Presentation to the Independent Planning Commission
re: Harbourside Shopping Centre Redevelopment (SSD7874)
(referred to as: Harbourside Proposal)

Jacqueline Lee
April 2021

Figure 21 | Podium envelope (above) and comparison of the podium envelope and the existing Harbourside Shopping Centre (below) (Source: Applicant's FFRTS)

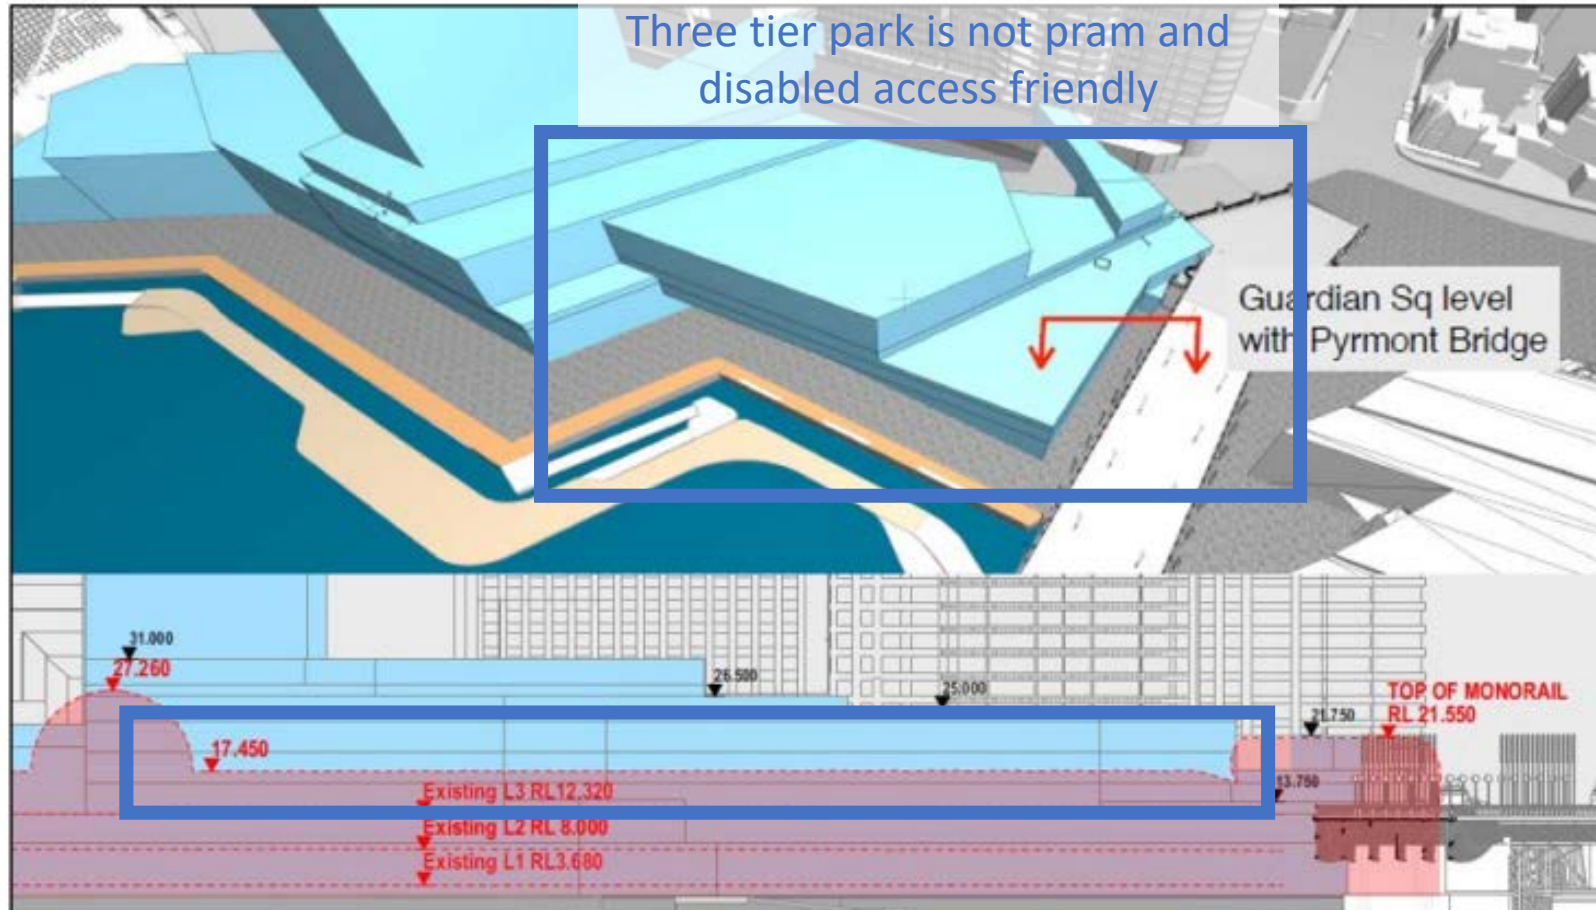
Existing height of current building is 17.45 for most of the building

Proposed building height of RL26.5 is more than double the bridge platform height of ~RL12.5

Dominates the Heritage Pymont Bridge

RL height should be reduced to a one level trafficable park of RL13.75 or RL17.5 (inclusive of landscaping) to be aligned with the Cockle Bay Redevelopment

Figure 42 | Indicative design of the northern publicly accessible open space and podium (source: Applicant's Amended EIS)

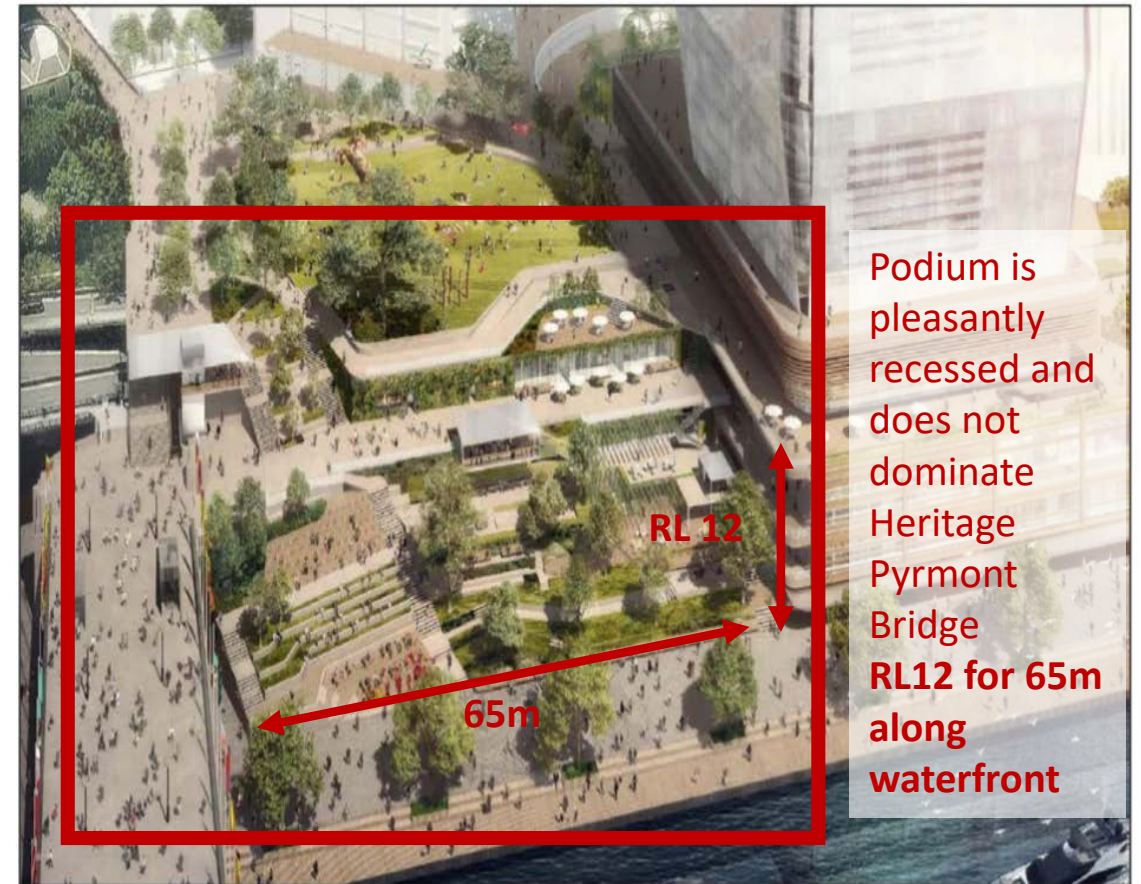
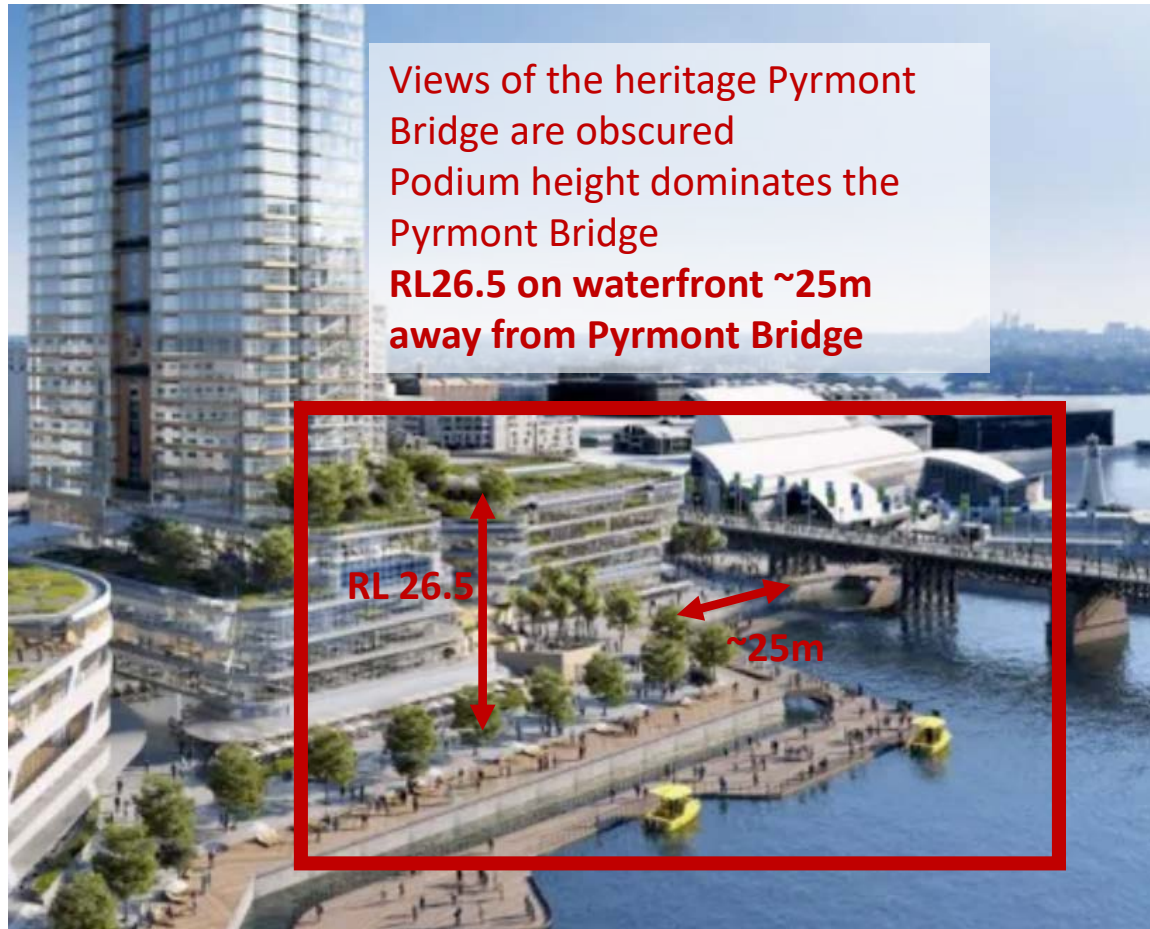
“the podium height would not challenge the visual dominance and heritage significance of Pymont Bridge”
– Department of Planning and Environment referring to Cockle Bay Redevelopment¹

“Northern Corridor” does not achieve View Sharing

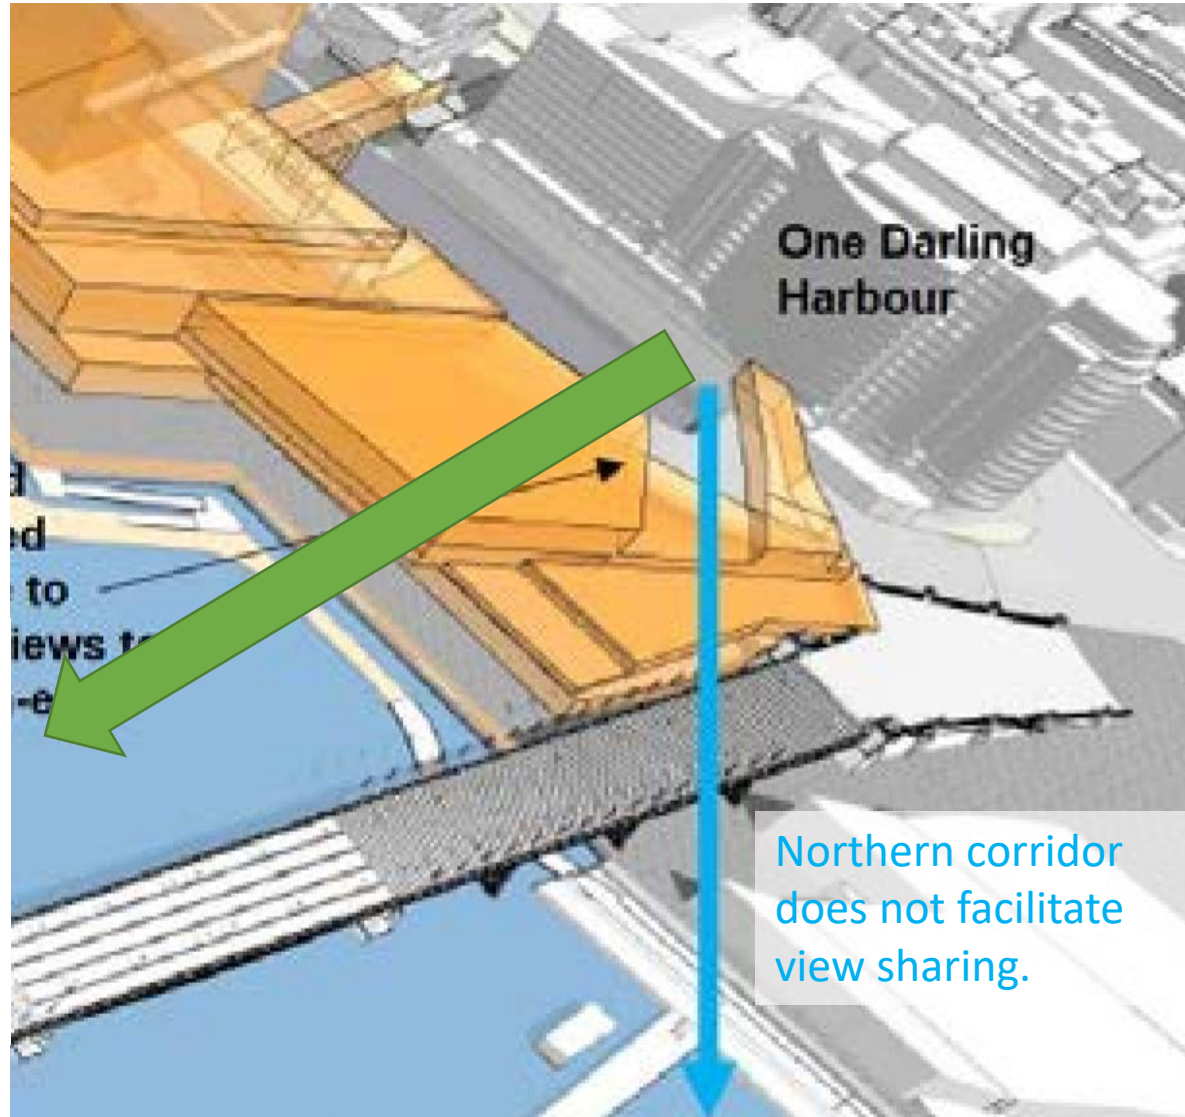
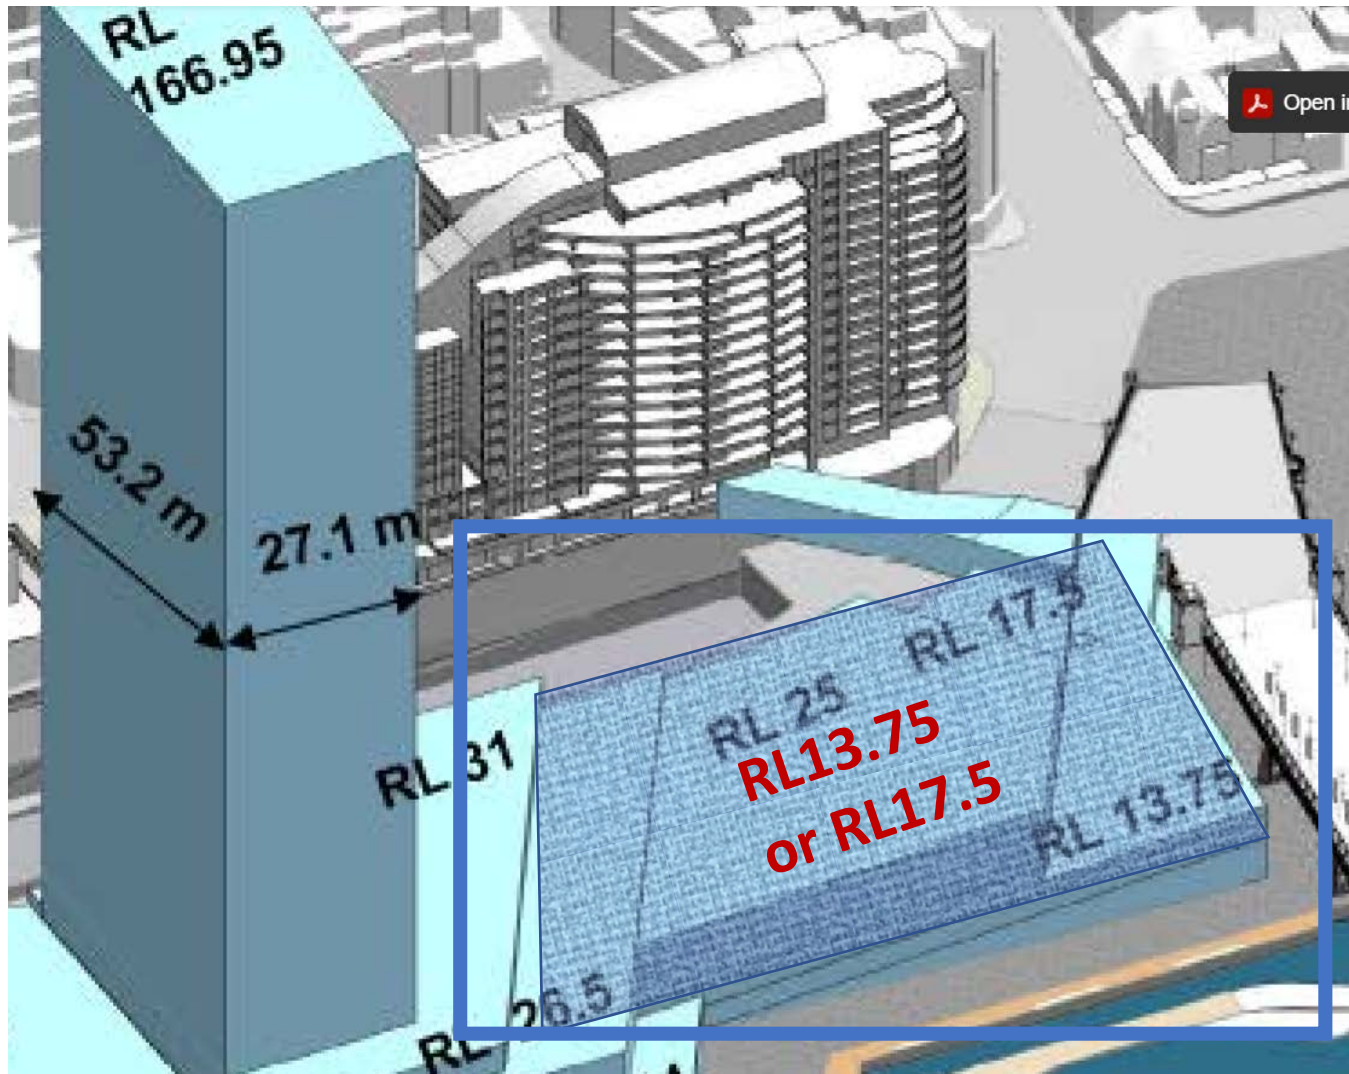
Actual One Darling Harbour sightlines due to curvature of building is directly of Cockle Bay. Northern Corridor has no impact on View Sharing.

Northern corridor does not facilitate view sharing.
